## IDAP REPORT

61 Oxford Road Strathfield
<b>Property:</b>	Lot 20 in DP 2338
	DA 2021/160
<b>Proposal:</b>	Demolition of all existing structures and trees on site to allow for construction of a two (2) storey dwelling with basement, pool, and a detached secondary dwelling.
<b>Applicant:</b>	P planning
<b>Owner:</b>	W & M Sleiman
<b>Date of lodgement:</b>	21 July 2021
<b>Notification period:</b>	30 July 2021 - 16 August 2021
<b>Submissions received:</b>	NIL
<b>Assessment officer:</b>	L Gibson
<b>Estimated cost of works:</b>	\$980,650.00
<b>Zoning:</b>	R2 – Low Density Residential - SLEP 2012
<b>Heritage:</b>	No
<b>Flood affected:</b>	Yes
<b>Is a Clause 4.6 Variation Proposed:</b>	No
<b>RECOMMENDATION OF OFFICER:</b>	<b>APPROVAL</b>

Figure 11: Roof plan of proposed development noting the variation in roof heights across the dwelling.

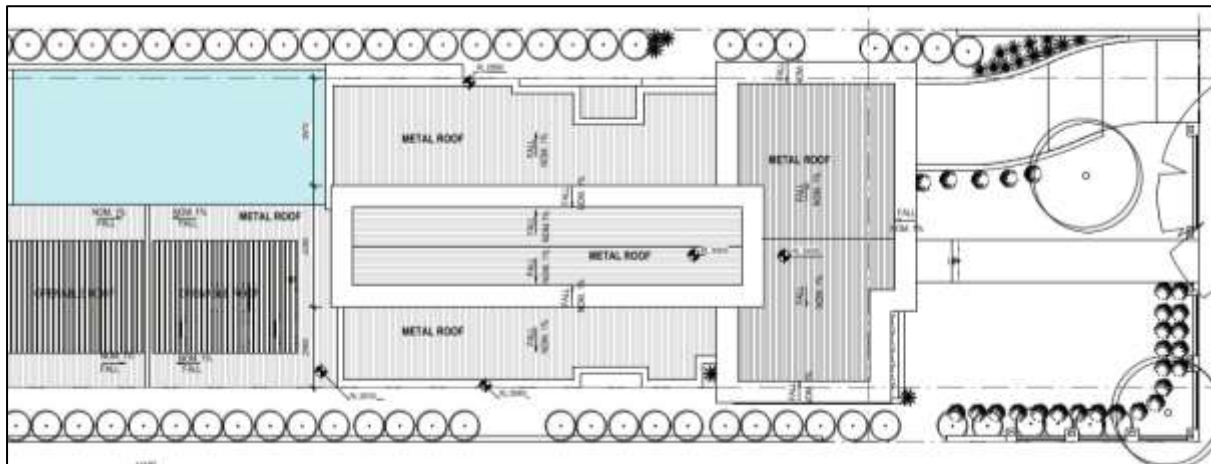
The internal wall of the two (2) void spaces over the living room areas extend to 6.95m in height. This exceeds the maximum 3m floor to ceiling heights permitted under the SCDPCP 2005. The void spaces are acceptable as they are contained within the central portion of the building. The pop-up roof is raised marginally higher than the surrounding roof line. Highlight windows are proposed around the entire periphery of the pop up roof immediately over the central void spaces so to enable natural light to flow through the dwelling. Whilst the roof heights are greatest through the centre of the dwelling in line with the void spaces, the surrounding remaining roof heights are substantially lower to a maximum height of 7.2m only. This reduces the apparent height and bulk of the dwelling as viewed from the street whilst reducing the dwelling's dependence on artificial lighting (refer to Figures 11 and 12 below for roof design).

Figure 13: Proposed concept landscape plan

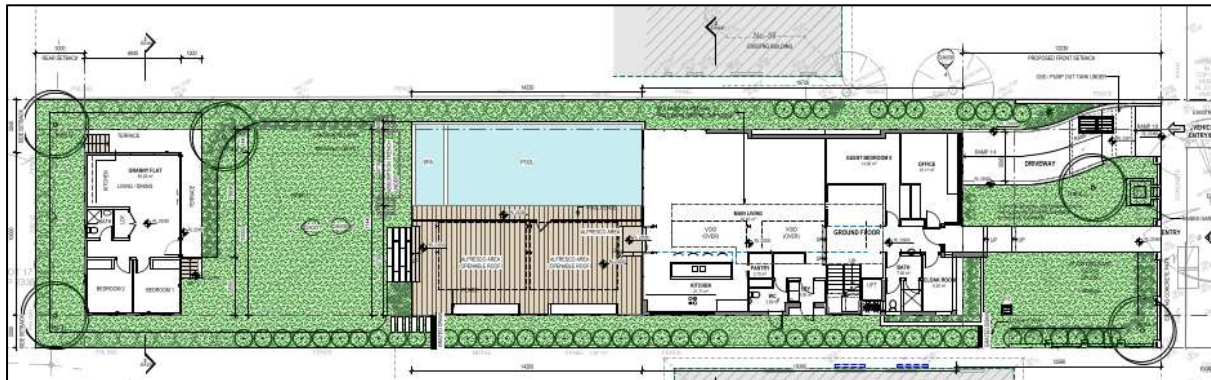
The proposed development satisfies the relevant objectives and controls of the SCDPCP 2005. The development provides for substantial deep soil planting through the site. The landscaping proposed is suitable to the scale of the development and provides ample opportunities for

canopy tree plantings to be provided both at the front and the rear of the site (refer to Figure 13 below for proposed landscape plan).

Figure 17: Shadow on elevation plans of adjoining dwelling at 63 Oxford Road, Strathfield.

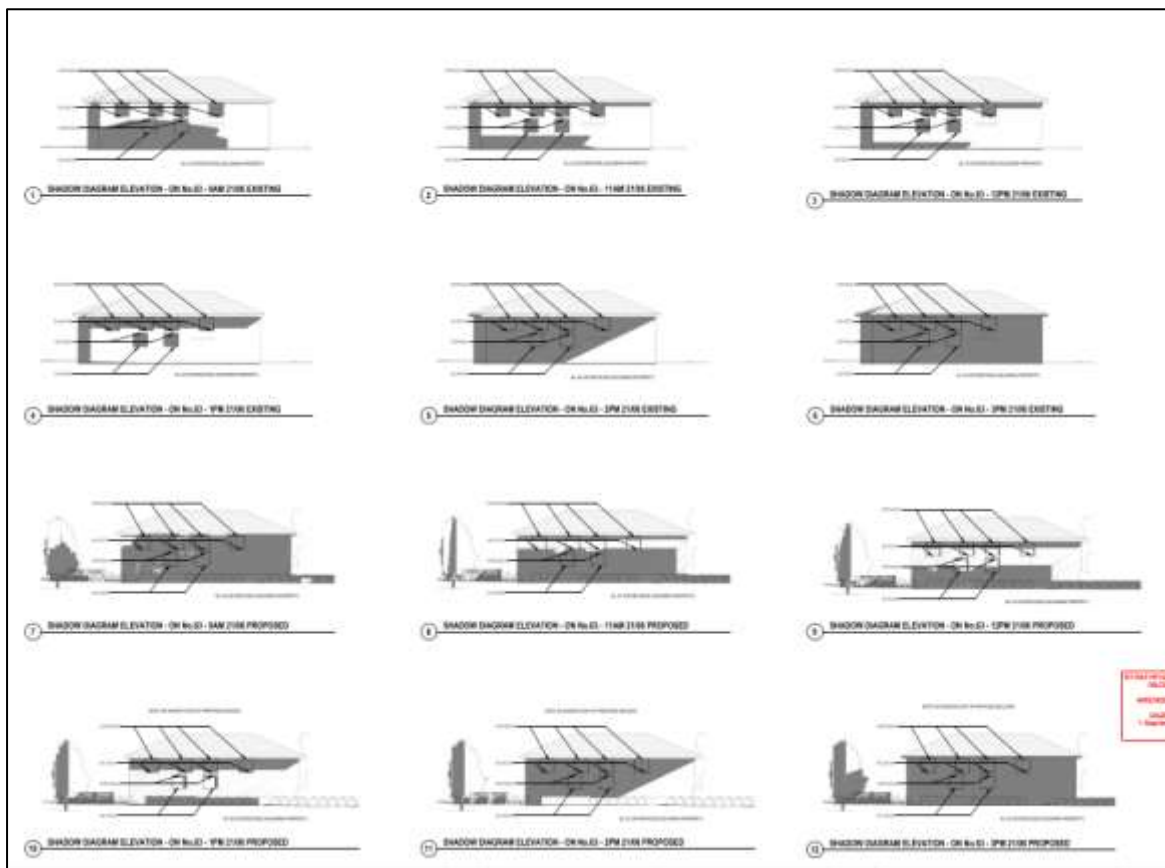
Based on the shadow plans and diagrams submitted to Council, it is evident that the proposal will cast a shadow over the southern adjoining dwelling at 63 Oxford Road, Strathfield. The diagrams demonstrate that whilst not all windows will be capable of receiving a full 3 hours of direct solar access through the day, the shadow moves considerably to ensure some direct solar access is received.

Almost all windows located across the adjoining dwelling's northern elevation will receive some direct solar access through the day. The proposal will also ensure that the front and rear open space areas of the site will receive a minimum 3 hours direct solar access through the day.

Figure 18: Proposed granny flat development

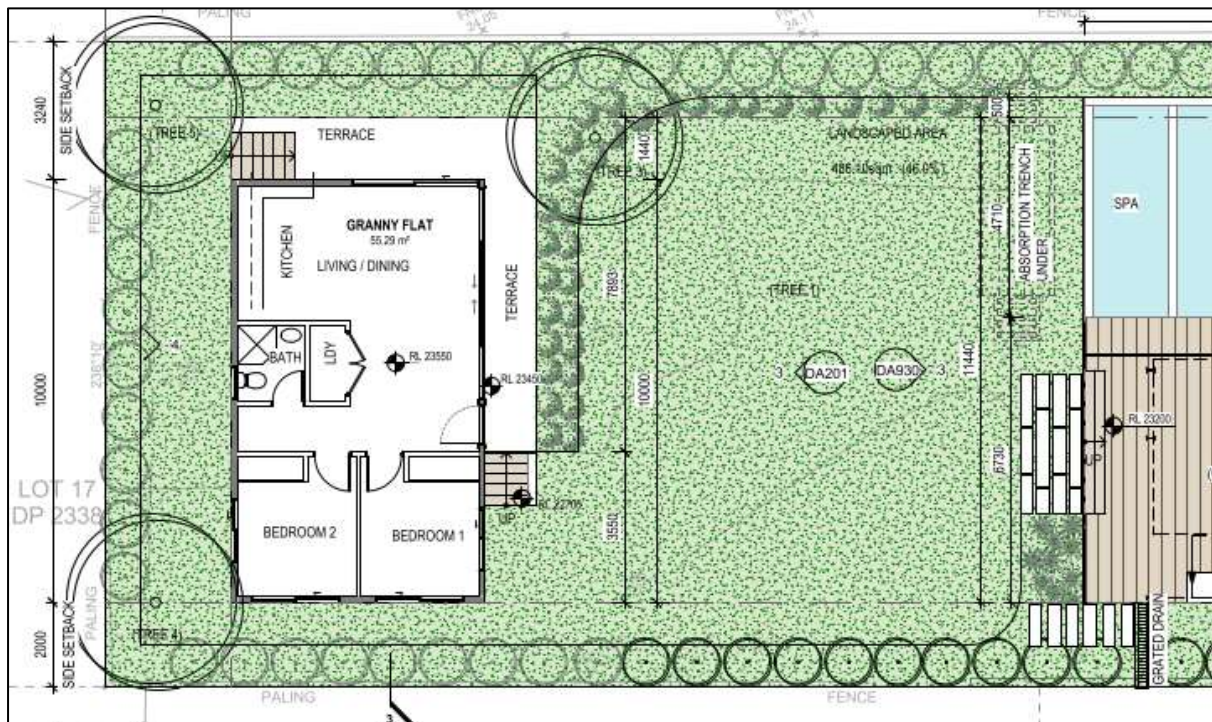
The proposed secondary dwelling has been designed so that it does not exceed 60m<sup>2</sup> floor area, is adequately setback from side and rear boundaries, and provides suitable open space provisions for the occupants (refer to Figure 18 below). The dwelling is single storey however, due to the flood affectation of the site, has been raised to a height of 910mm above natural ground. The proposal has sought the sensible location and treatment of windows and openings however, given the raised height of the structure, the proposed terrace which wraps around the eastern and western elevations of the secondary dwelling will result in direct opportunities for overlooking into neighbouring properties.

Section 12.2.1 of Part A of the SCDP 2005 requires the primary private open space area to be directly accessible to the internal living areas of the dwelling. Ample private open space areas are provided around the northern, eastern and southern peripheries of the secondary dwelling to achieve reasonable amenity for future residents. Notwithstanding this, due to the substantially raised floor level of the dwelling, a condition of consent is required for the terrace to either be deleted or lowered to natural ground level with the exception of the stairs and stair landing upon the southern elevation of the building for access. This will reduce opportunities for overlooking into adjoining properties.
